INITIAL INSPECTION REPORT OF VEHICLE NO SHA 5859G

Affiliated to Federation Internationale Des Experts En Automobile				
MS FIRST CAPITAL INSURANCE LTD			Ref : CS/FCI19011375/Dvd3n2	
36 ROBINSON ROAD #16-01 CITY HOUSESINGAPORE 068877			Date : 25-07-2019	
			Code : FCI2

ADJUSTMENT ON REPAIR COST FOR VEHICLE NO. SHA 5859G

Description of Damage:

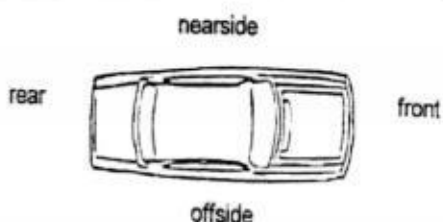
The vehicle sustained damages at the front and rear portion

Damages Consistent
